**MEMORANDUM OF COUNSEL ON BEHALF OF THE QUEENSTOWN LAKES  
DISTRICT COUNCIL REGARDING AMENDED STRUCTURE PLAN FOR THE  
JACKS POINT ZONE**

**28 February 2017**

**APPENDIX 1**  
**AMENDED STRUCTURE PLAN**

Jacks Point Resort Zone  
Council Right of Reply Structure Plan 24 Feb 2017

FIGURE 1

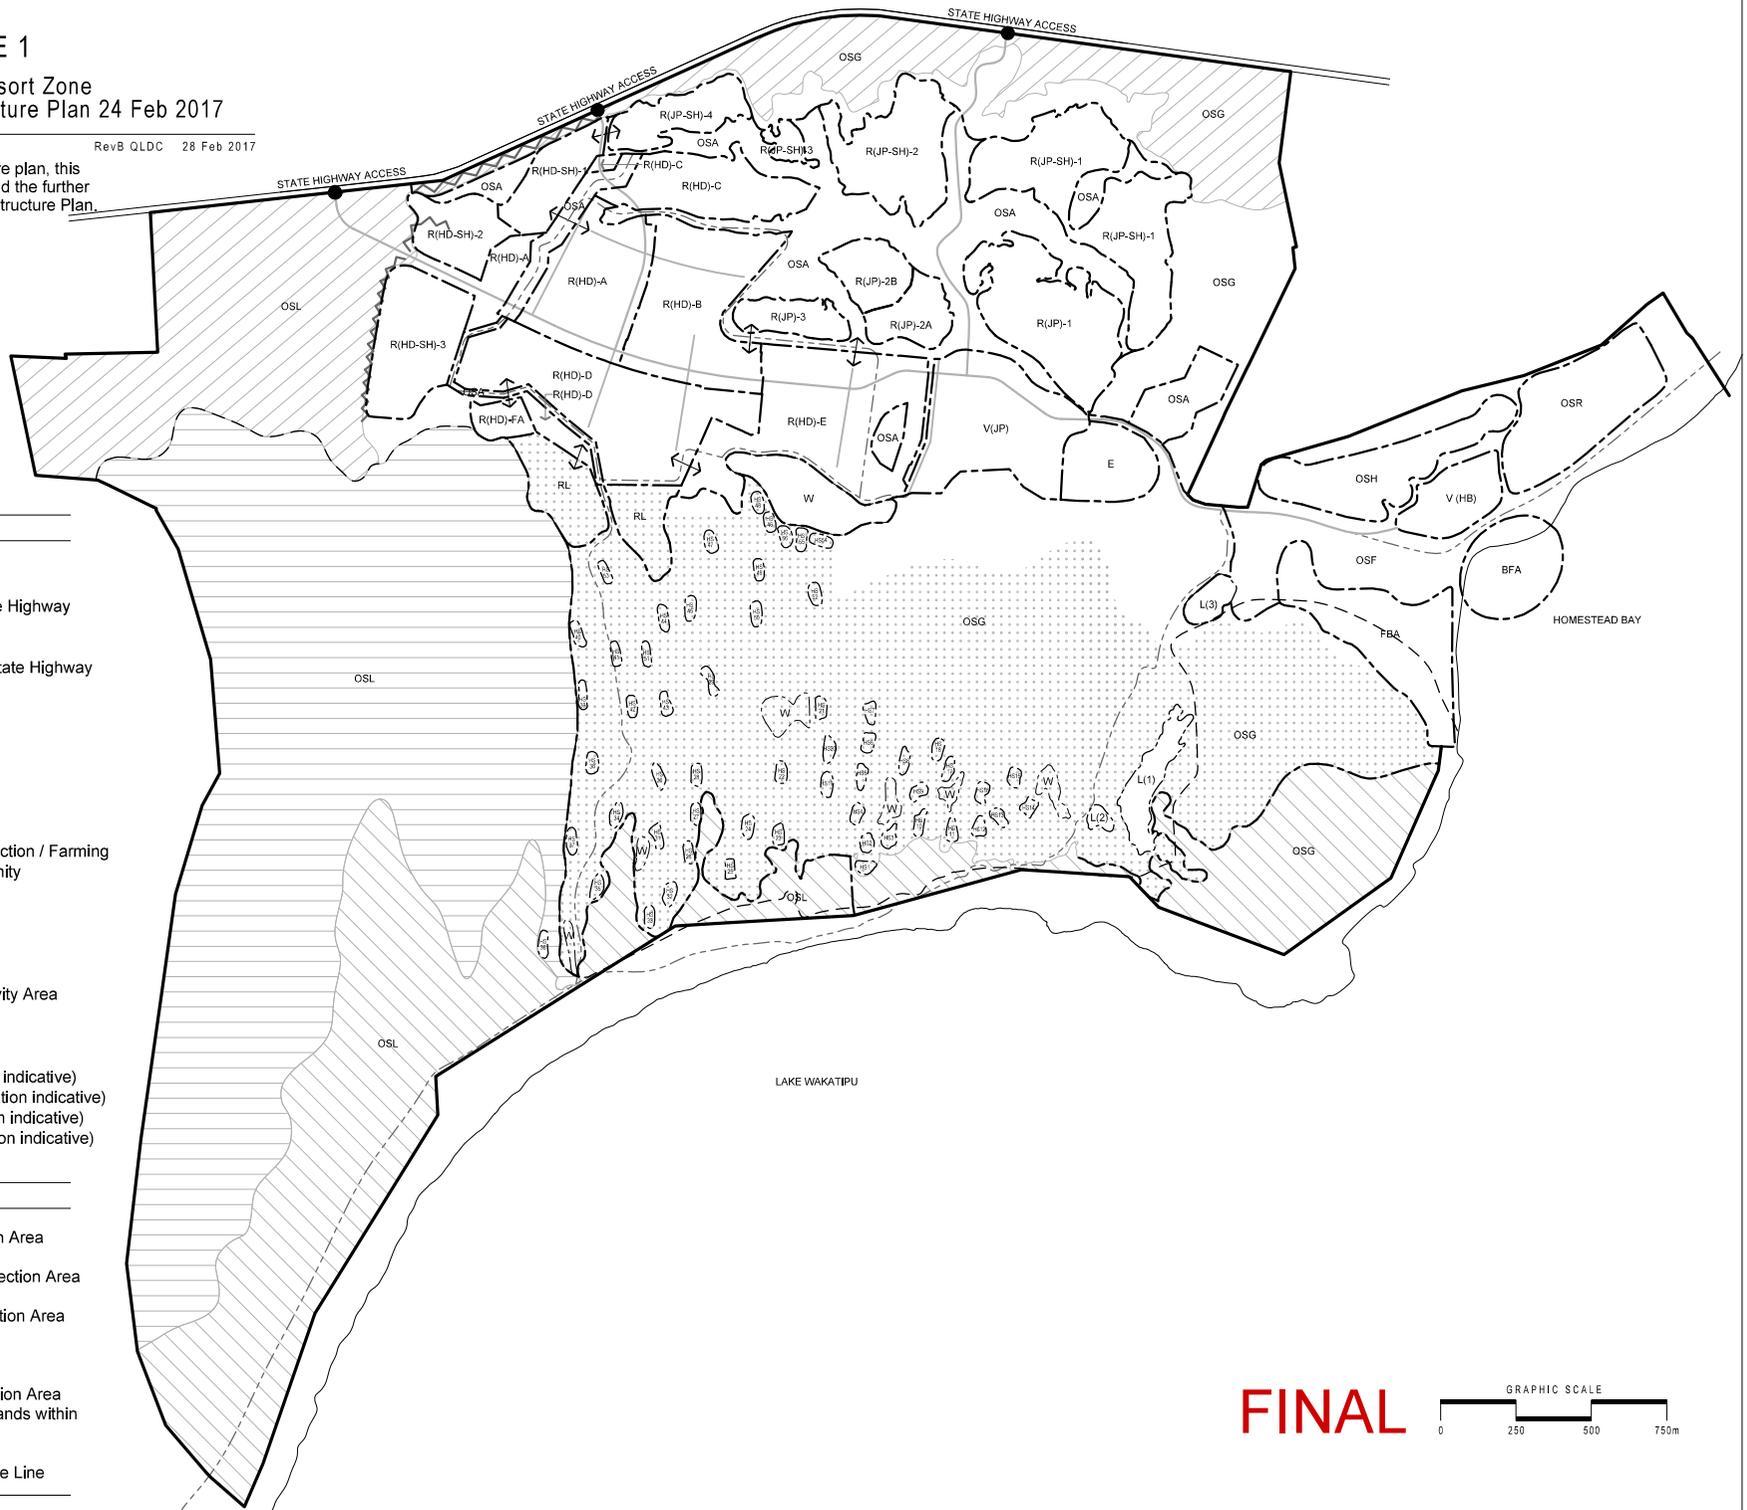
3. The only change to the Structure Plan is the extension of the Tablelands Landscape Protection Area overlay to include approximately half of Jacks Point hill. This is consistent with the version of the Structure Plan included in Ms Jones' section 42A report. There was an error in its application in preparing the right of reply Structure Plan. The Council confirms that the amendment does not represent a change from Ms Jones's recommendations.
